Project Amendment Addendum

Surface Water Assessment

AECOM Australia Pty Ltd (AECOM) continues to act on behalf of the applicant, 892 Yarrowonga Development C/- South Energy, in relation to Planning Permit Application No. PA2000978 for the West Mokoan Solar Farm.

This letter is an addendum to the Surface Water Assessment (Date 21/09/20) (*The Report*).

SHEET NUMBER: 60057909-DWG-EL-0005

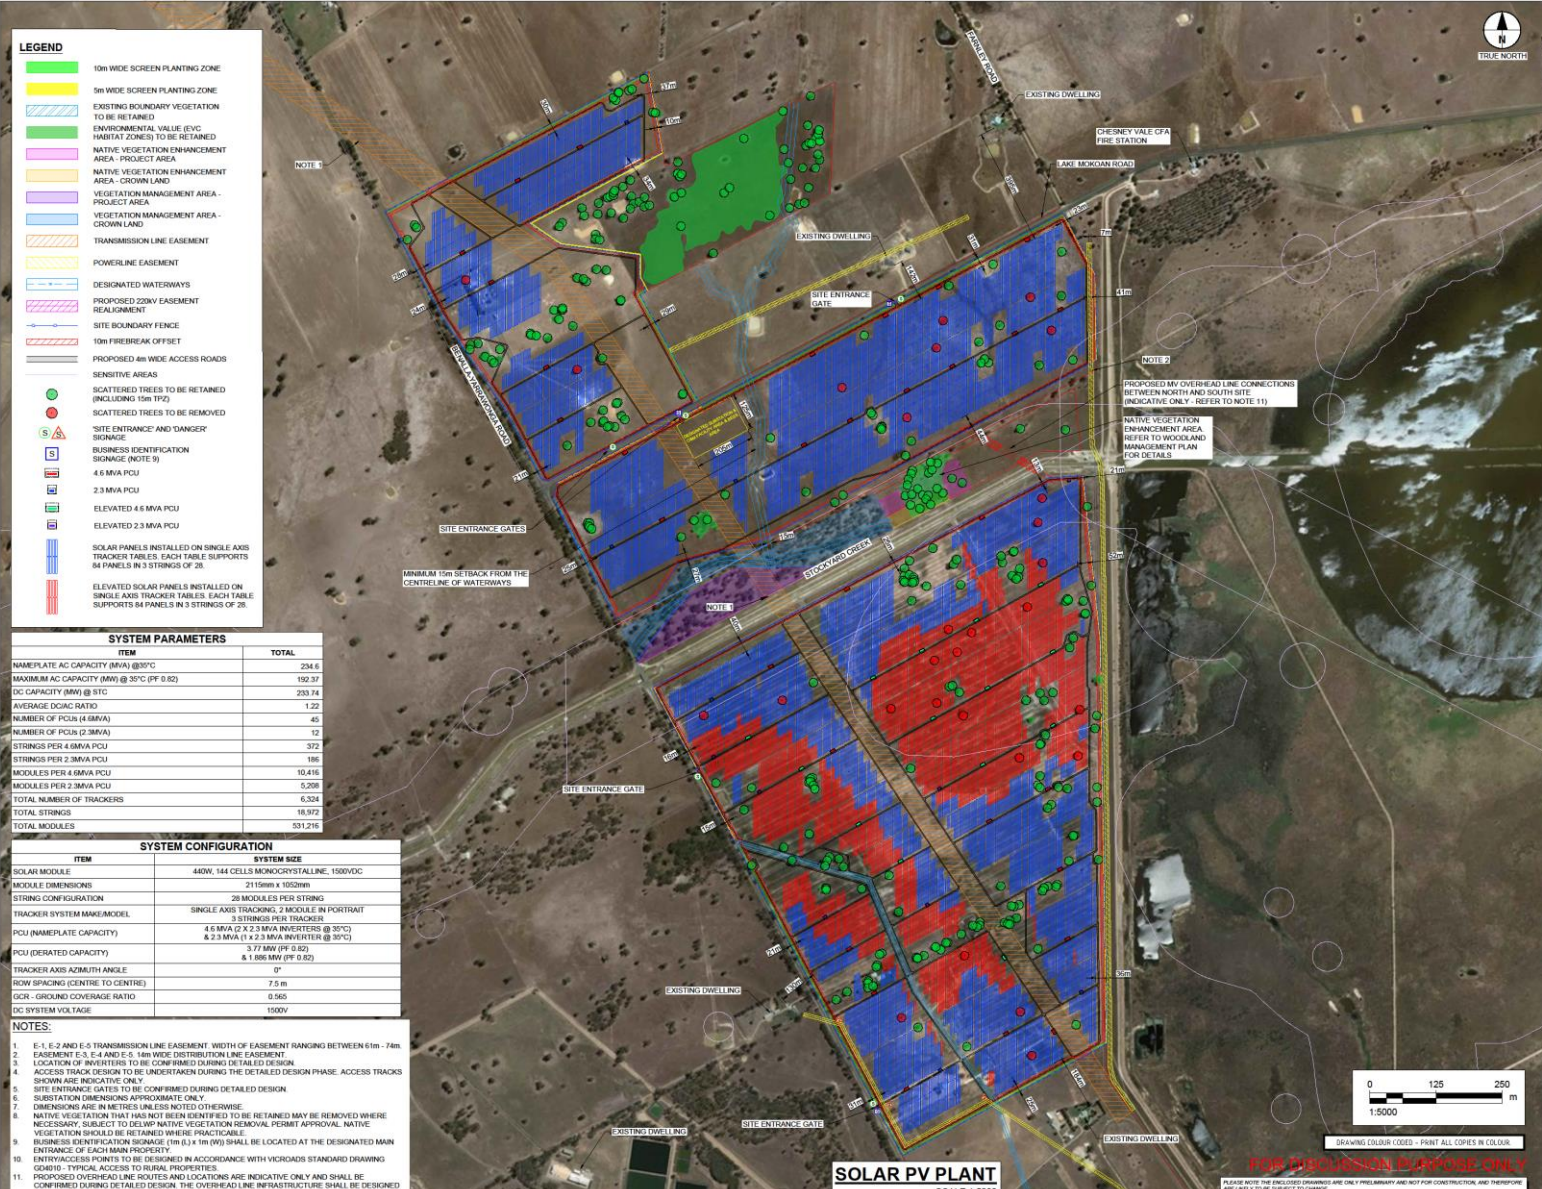
A review of the revised Concept Plan (60597809-DWG-EL-0003_Rev11 dated 3/6/2021), presented in Appendix A was undertaken to confirm any surface water impacts as a result of the changes to the project described above.

The Report provides high level guidance for the siting of a substation (Section 5.3). This guidance was informed by the Goulburn Broken Catchment Management Authority (GBCMA) who advised that finished floor levels must be constructed to a minimum of 300mm above the 1% AEP Flood Level and set back from designated waterways. The revised substation location is set back from the designated waterways and will still allow for the substation design to meet these requirements.

The Report outlines the impacts of vegetation removal and highlights the importance of timely land remediation (Section 5.7). Retaining more native vegetation across the site could potentially reduce the area of soil disturbance and therefore, sedimentation impacts.

The project area has been revised following the removal of land at 81 Lake Mokoan (Lot 2 PS625748) resulting in minor changes to the layout of solar energy infrastructure (Table 1). The revised layout presented in Appendix A and B does not encroach on the designated waterways or their agreed setbacks. The siting of solar energy infrastructure has also been designed in accordance with the requirements of the GBCMA.

The proposed amendments to the Project area and technical requirements in response to the RFI's raised by DELWP, dated 5 November 2020, and DELWP – Hume Region, on 26 November 2020, have been reviewed against the Surface Water Assessment (Date 21/09/20).

Based on the planning amendments outlined herein, it is proposed the Surface Water Assessment remains unchanged. It should also be noted that the scope, assumptions, and limitations presented in the Surface Water Assessment are applicable to the conclusions presented in this addendum.
